BID ADDENDUM NO. 1

**Curb Ramp Upgrades Sierra Bonita -
Queenanne Road (CDBG Funded)**

DPW PROJECT NO. 18-06

BID ADDENDUM ISSUE DATE: April 9, 2019

DRAWN BY: KGE DESIGNED BY: DATE: 8/7/09 FILE NAME: PR-C-8.1.DWG	CITY OF PASO ROBLES ENGINEERING DIVISION CURB RAMP DETAILS	DRAWING NO. C-8.1
---	--	--------------------------

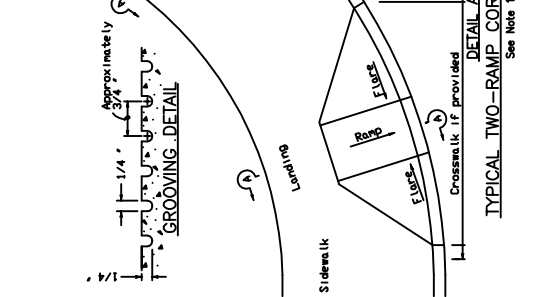
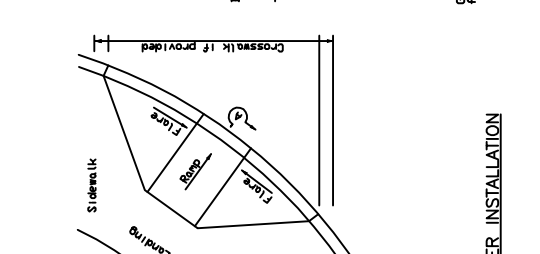
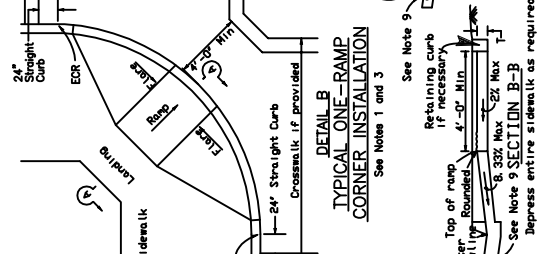
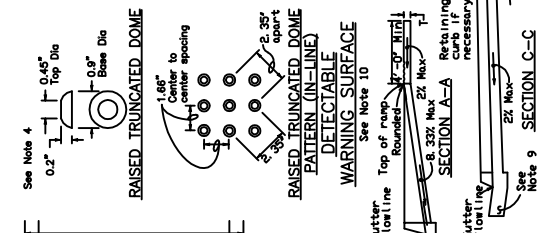
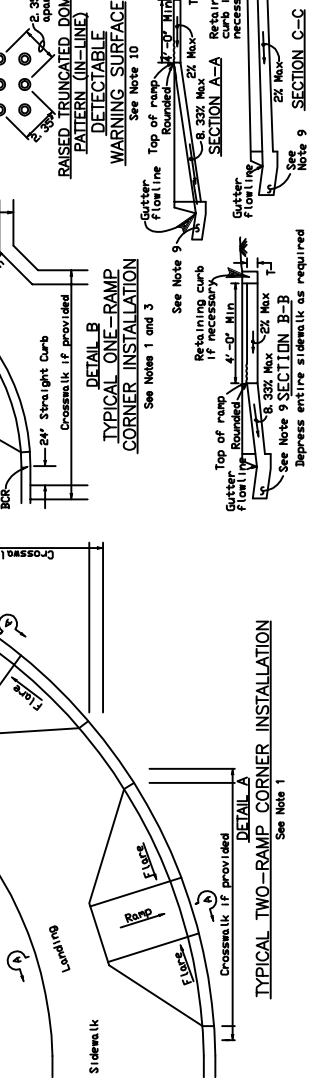
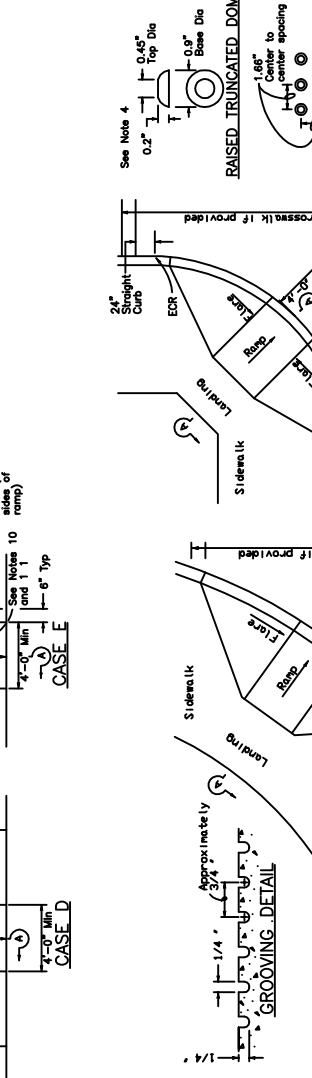
- 2). See attached Detail C-8.1 Retaining Curb. It is the City's intent that the retaining curb is unreinforced concrete, 6-inches wide, with depth measured from the finished grades as shown on the plans to the bottom of the sidewalk.
